802.3as Frame Expansion

Changes to Clauses 2,3 & 4

802.3as editor

March 2005

IEEE 802.3as/Figure 3-1
MAC frame format

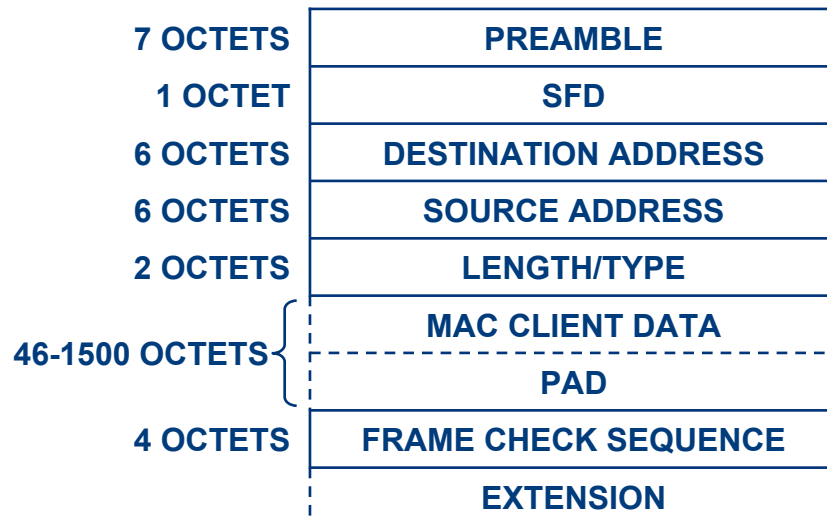
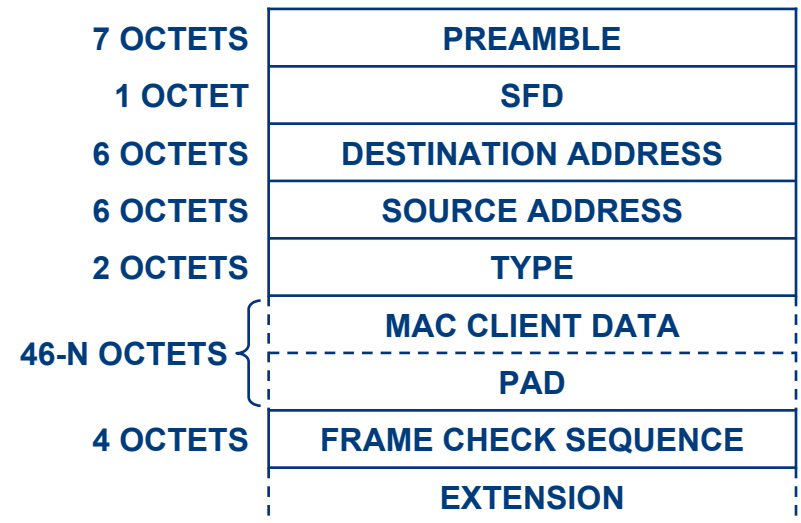
Remove clause 3.5 – Tagged Frame
